From: Detterman, Mark, Env. Health
Sent: Thursday, August 13, 2015 5:17 PM
To: 'Carl J. Michelsen'
Cc: GrafCon; Dave Hopkins; Cunningham, Denise; Kamangar, Katia; Justin J. Patterson
Subject: RE: Summary of Conference Call

Per your request, the following provides a summary of our discussion regarding your Workplan conditional approval letter and the changes to the upcoming subsurface investigation:

Site Plan and Proposed Sample Locations
39155 and 39183 State Street
Fremont, California

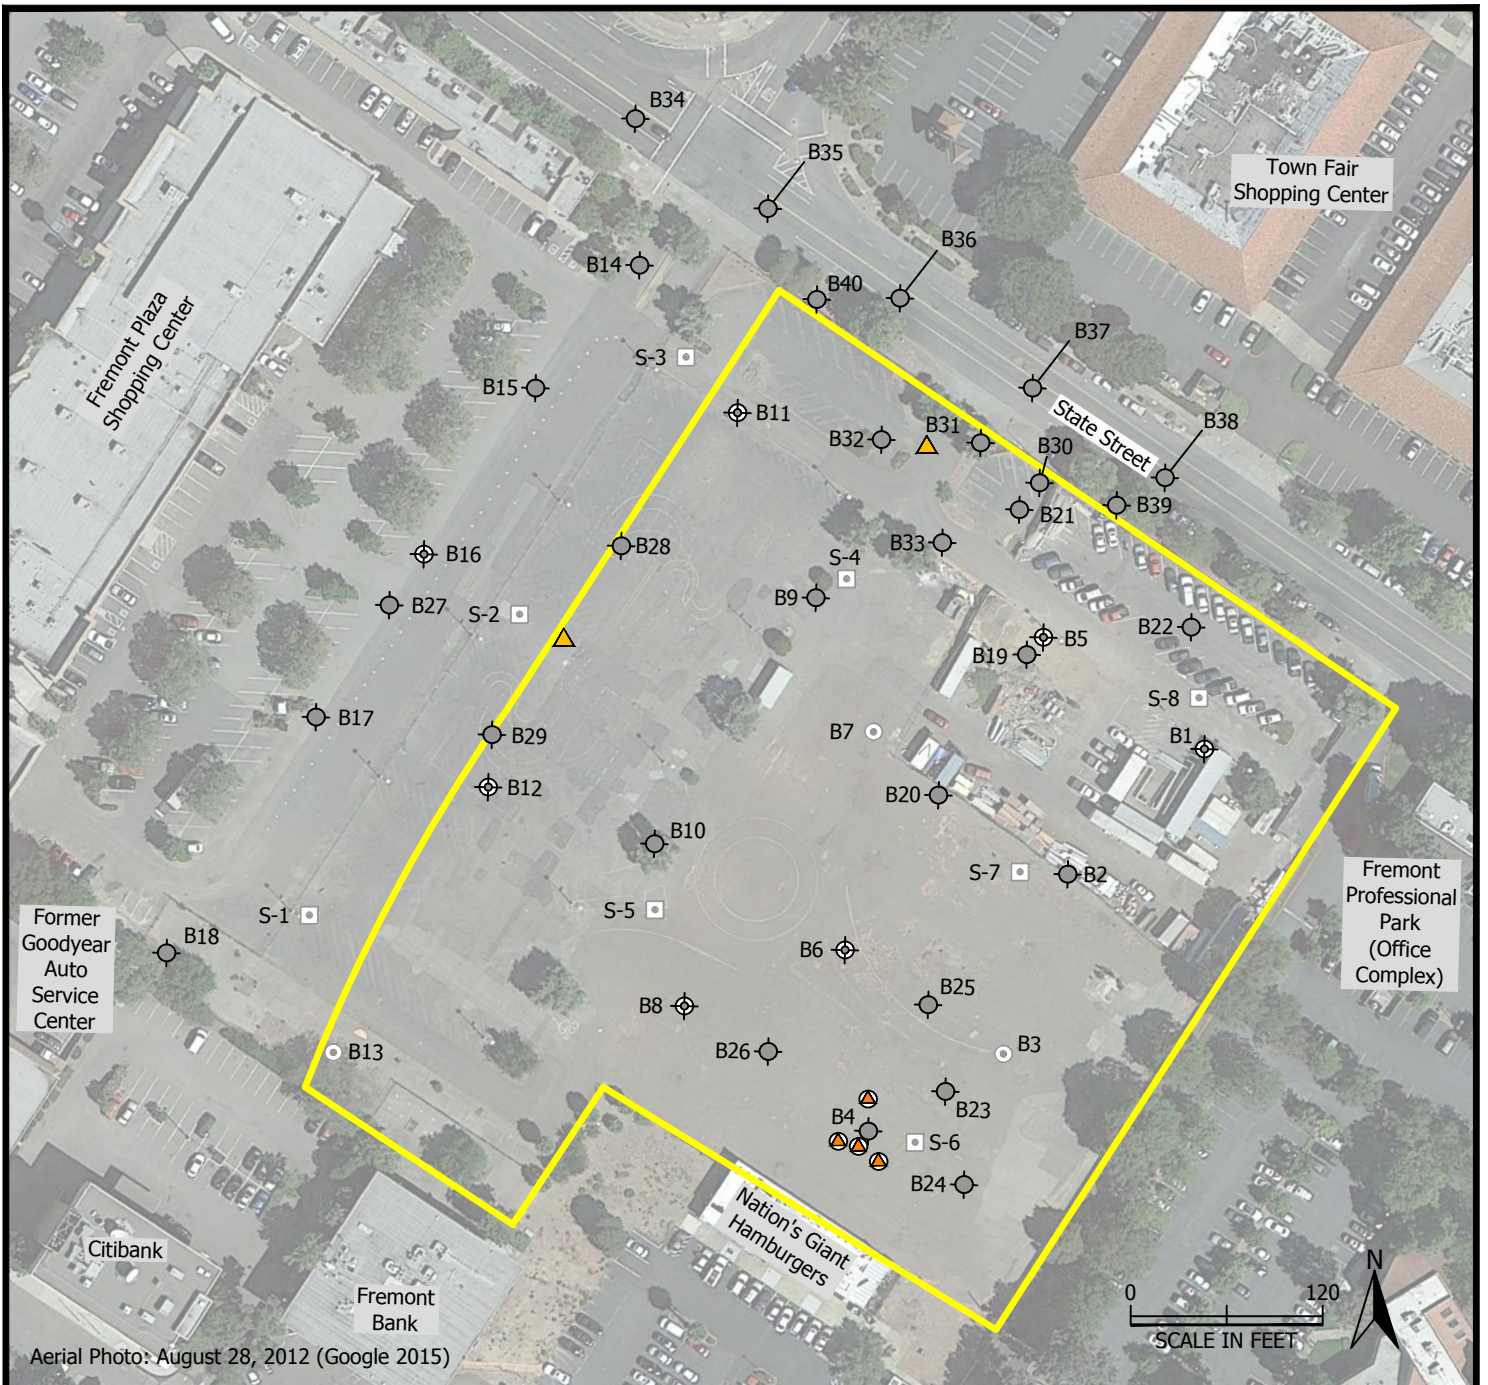
Carl,
Thanks for the summary. The reasoning appears sound. In regards to Buildings A & B, I would request the soil type for the entire 12 foot excavation depth be considered, and not just the upper 5 feet. One item that did not come up and I didn't think to request in the letter, is to request that all bores be logged. They always provide useful information and is a standard ACEH request.
Thanks; looking forward to seeing the data.

- 1) The three proposed soil/soil vapor borings surrounding boring B4 will be moved in so that they are spaced at a distance of 20 feet from boring B4.

- 5) PES will add two new borings within the footprint of the planned parking garage on the northwestern portion of the site. One location will be located between the prior borings B31 and B32. The second boring will be located between prior borings B28 and B29. Each boring will be advanced to approximately 13 feet below ground surface to collect a soil vapor sample.

Attached please find a revised Plate 2 that shows the new boring locations described above.
